NORTH DAKOTA DEPARTMENT OF TRANSPORTATION
CHANGE ORDER

PROJECT IM-8-029(026)053**EXPLANATION OF
CHANGE ORDER 4P-4C****INCREASE TO BID ITEMS:**

The plans do not address the replacement of the south approach slab at this location. Because of the 0.32' settlement of the approach slab, it is necessary to replace the approach slab which will provide a smooth profile and transition from the new mainline concrete to the Rose Coulee Structure.

ROSE CULLEE
 NORTHBOUND I-29
 40th AVE. S. OVERPASS
 APPROACH SLAB
 ENTRANCE END

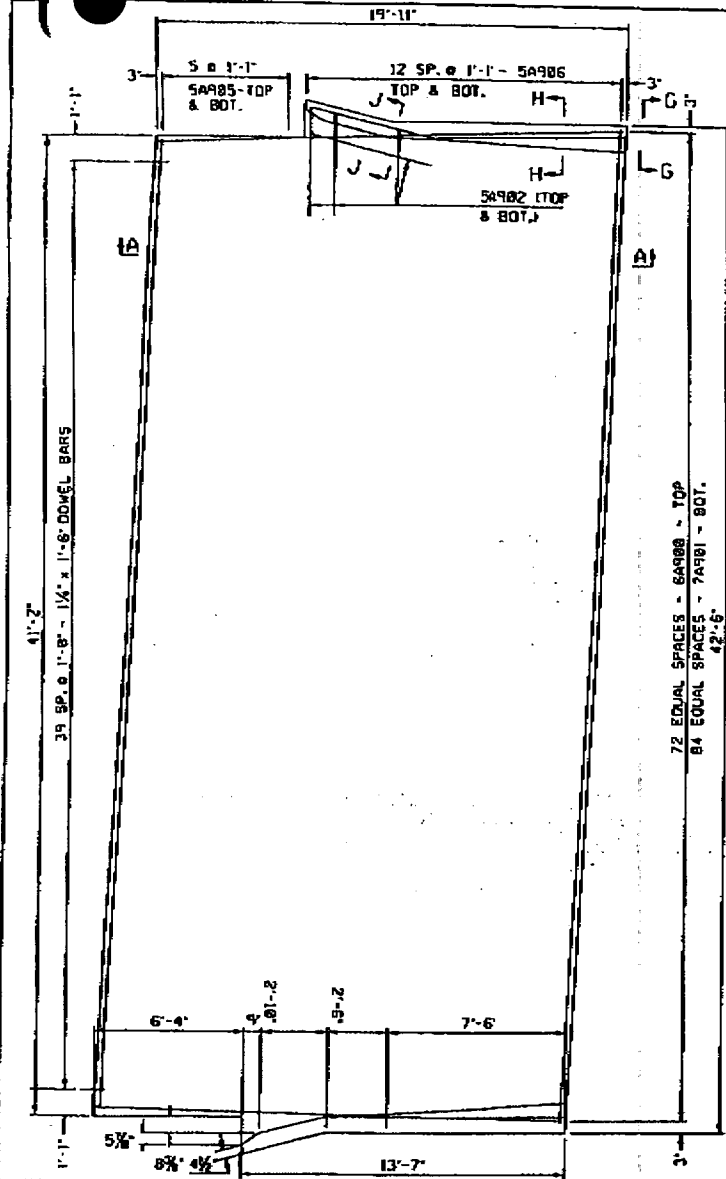
The design of the approach slab, not including the safety shape transition, is the same as shown for 40th Ave. S. overpass. This is found on sheet #45 in the plans CPU-8-984(007). The design for the safety shape transition is the same as shown for the Wild Rice River Structure located on sheet #104 in the plans IM-8-029(026)053. The quantities for the approach slab for the Rose Coulee Structure is estimated at 7,849 lbs for reinforcement steel and 93.5 SY for concrete.

ROSE COULDE
APPROACH SLAB JOINT DETAILS

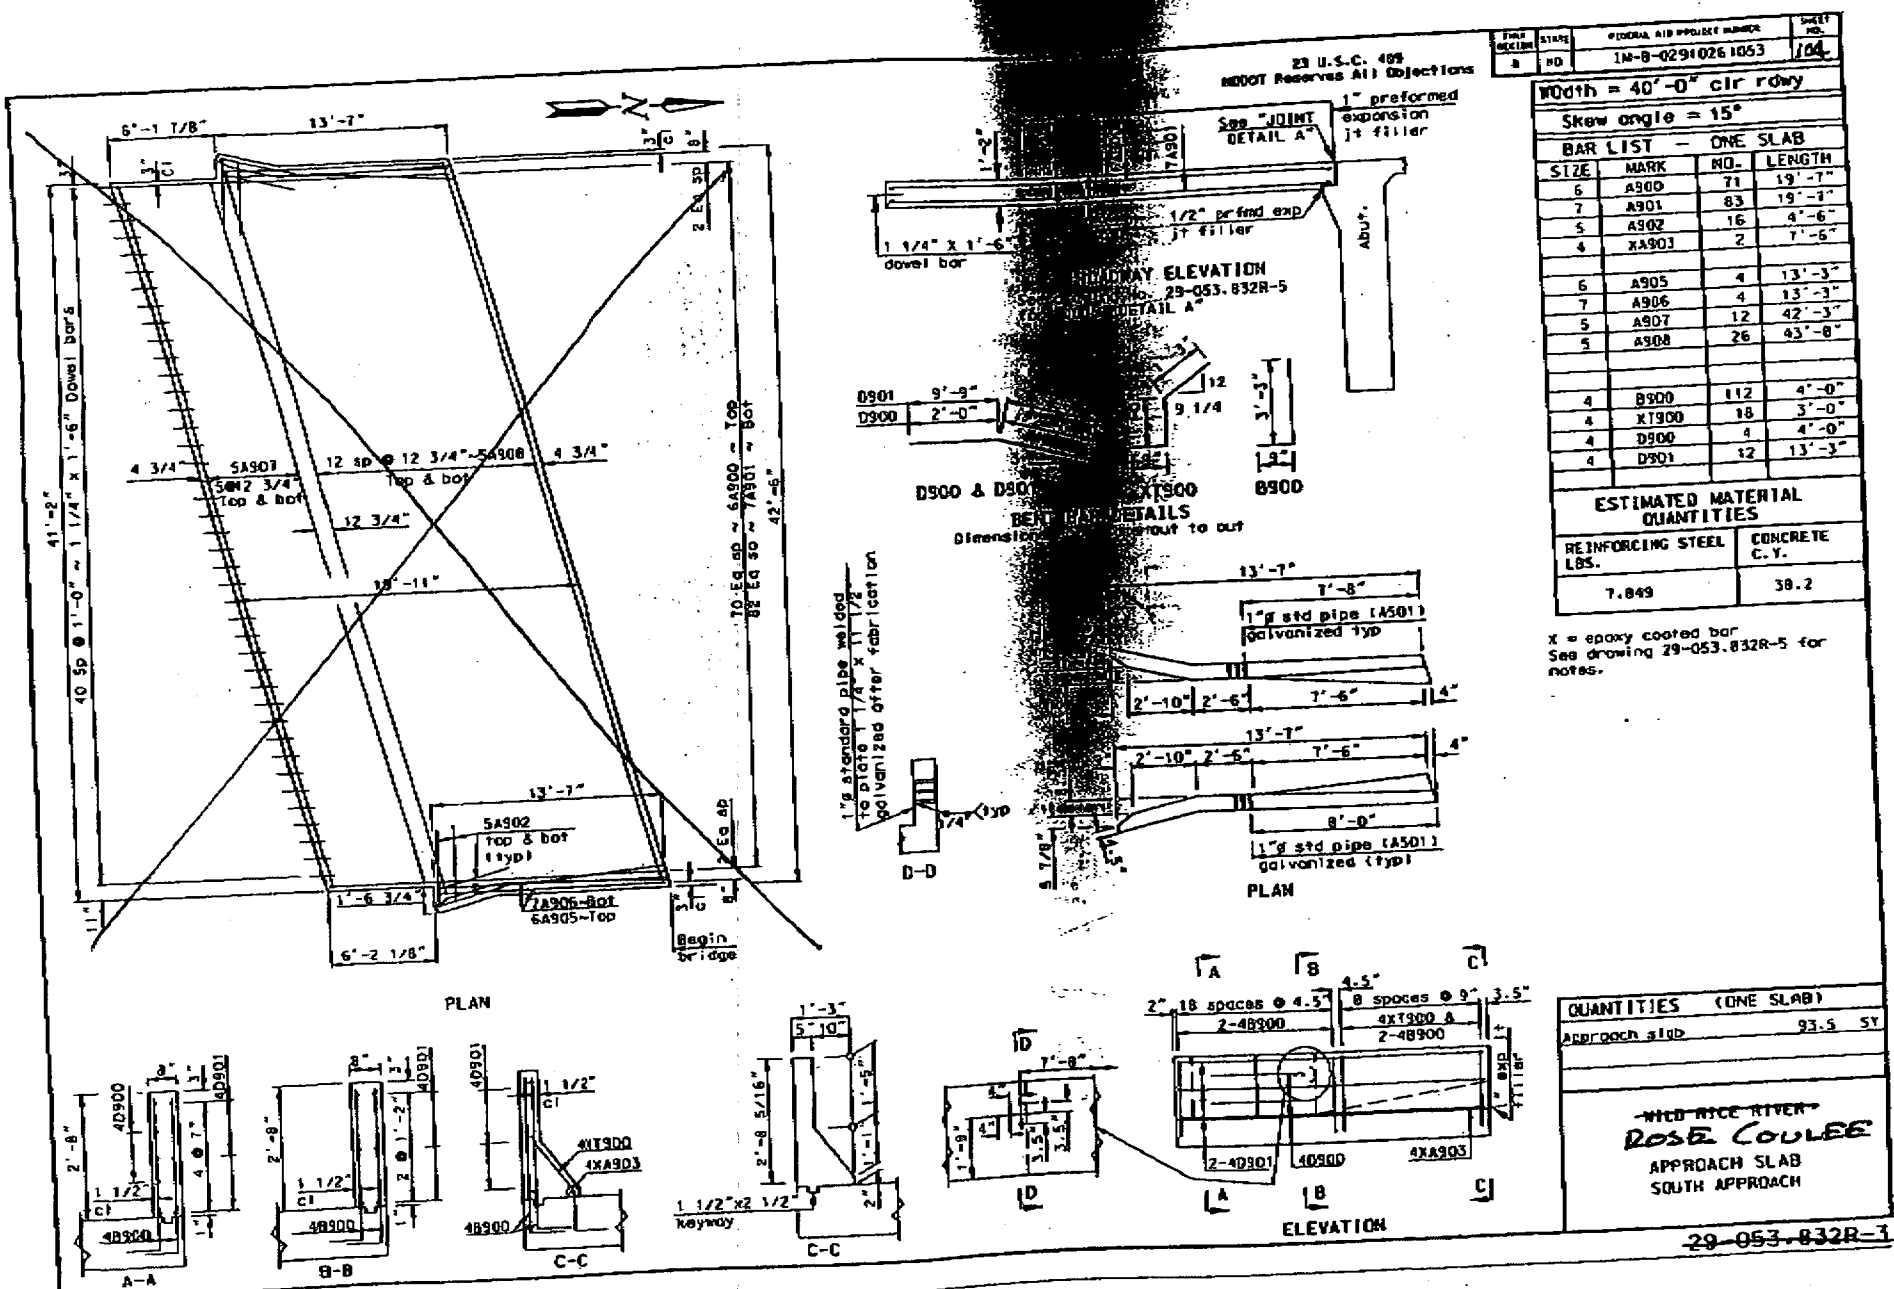
The design of the nosing concrete and silicone sealant for the approach slab at Rose Coulee is the same as shown on sheet #106 in the plans IM-8-092(026)053. The nosing concrete will be 4.0 CF and the silicone sealant will be 41.5 LF.

(A) 12'-6" DOUBLE RAIL SECTION

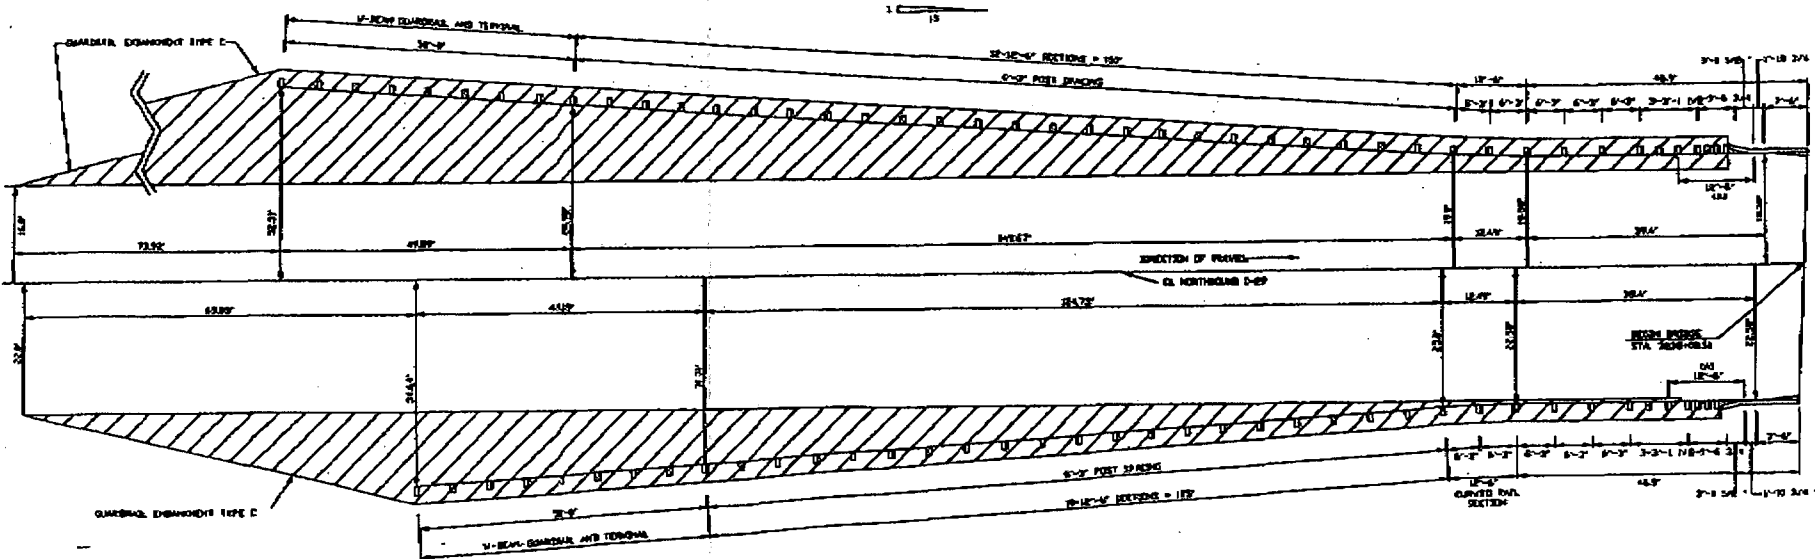
The guardrail embankment and guardrail on the south end of the Rose Coulee Structure is in conflict with work that is required to reconstruct the mainline. The plans did not address the removal of the w-beam guardrail on the south end of the Rose Coulee Structure. Removal of this guardrail will also be needed for the construction of the new safety shape transitions that will be built with the approach slab.

The design for the guardrail will be the same as shown for the 40th Ave S overpass which is shown on plan sheet #52 in the plans CPU-8-984(007). The roadway width and lane widths are the same as shown on this sheet. The NDDOT Traffic Section of Design was called to verify that this design for guardrail at this location was correct.
